FRONT SUSPENSION POPPING NOISE WHILE TURNING RIGHT OR LEFT—VEHICLES BUILT BEFORE 4/8/2005

TSB 07-18-1

FORD:
2005 Mustang

This article supersedes TSB 05-9-11 to update the Part List.

Figure 1 - Article 07-18-1

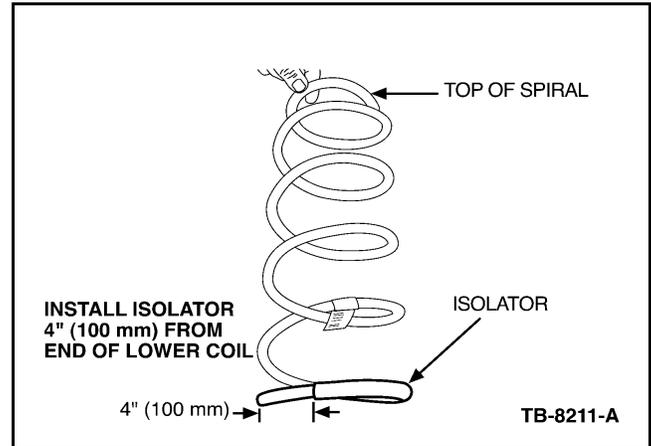
1. Remove the strut and spring assembly. Refer to Workshop Manual Section 204-01.
2. Disassemble the strut and spring assembly.
3. If the springs do not have a rubber isolator on the bottom spring coil, install isolators. Clean off any dirt prior to installing the isolator. The isolator should be installed 4" (100 mm) from the end of the coil (Figure 1).
